NINE MILE POINT NUCLEAR STATION, UNIT 2

AMENDMENT TO FACILITY OPERATING LICENSE

Amendment No. 77  
License No. NPF-69

AMENDMENT NO. 77 TO FACILITY OPERATING LICENSE NO. NPF-69

FIGURE 3.3.2-1 Allowable and Trip Setpoint Values for the Main Steam Line Tunnel Lead Enclosure

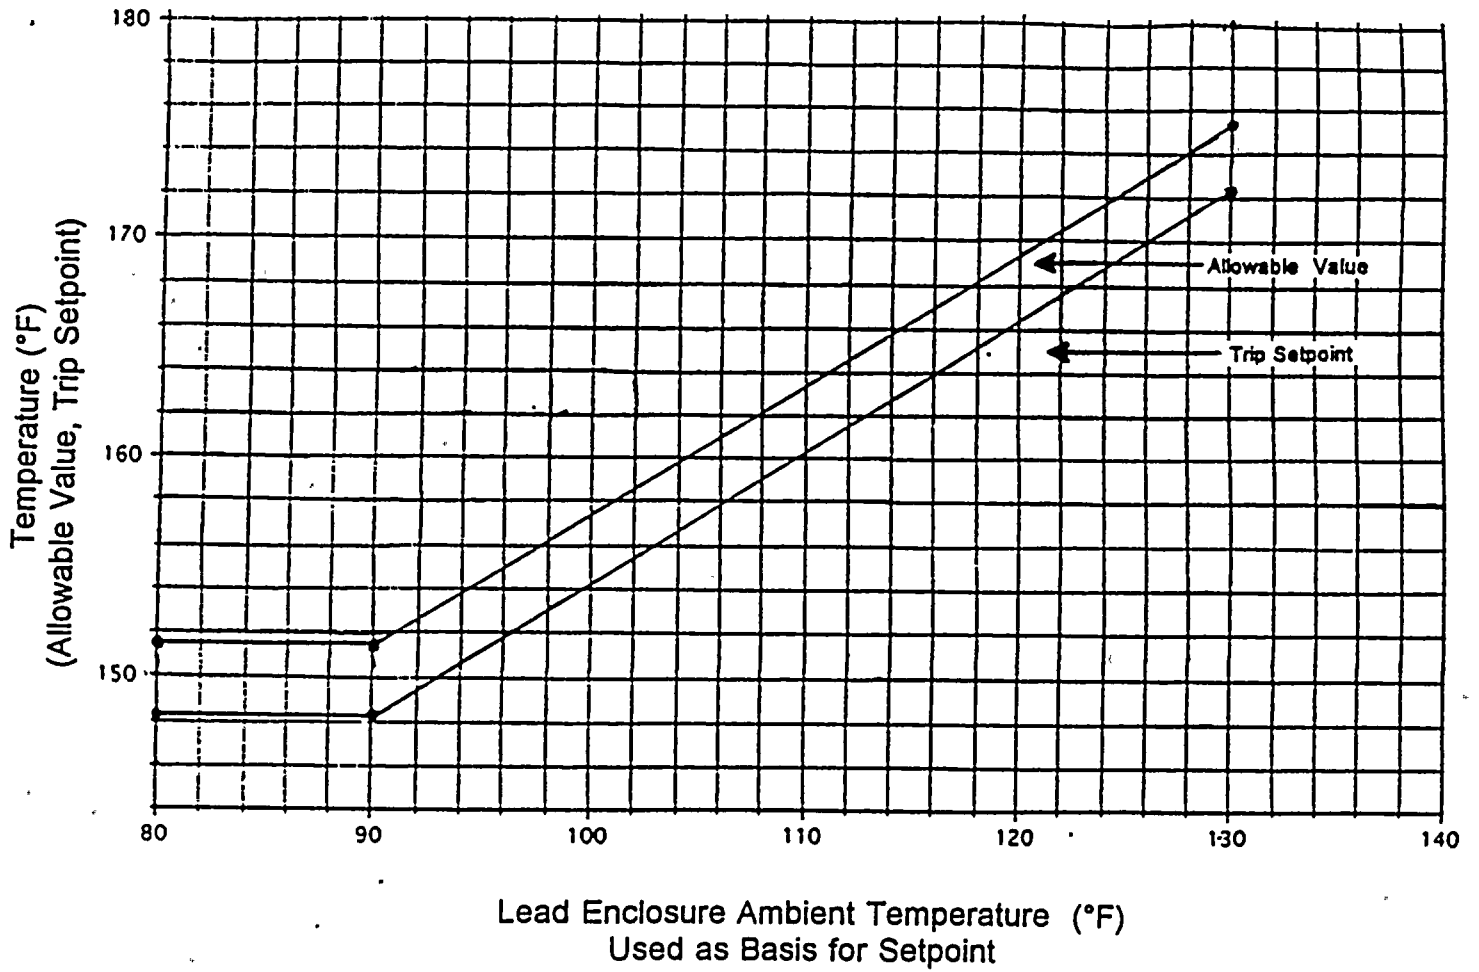
- \*\*\*** The trip setpoint and allowable value for a channel may be established based on Figure 3.3.2-1, if:
- a. the actual ambient temperature reading for all operable channels in the Lead Enclosure area are equal to or greater than the ambient temperature used as the basis for the setpoint, and

- b. the absence of steam leaks in the Main Steam Line Tunnel Lead Enclosure area is verified by visual inspection prior to increasing a channel setpoint, and

- c. a surveillance is implemented in accordance with Note "d" of Table 4.3.2.1-1.

- (d) In addition to the normal shift channel check, if a channel setpoint has been established using Figure 3.3.2-1, then once per shift the actual ambient temperature reading for all operable channels in the Lead Enclosure area shall be verified to be equal to or greater than the ambient temperature used as the basis for the setpoint.
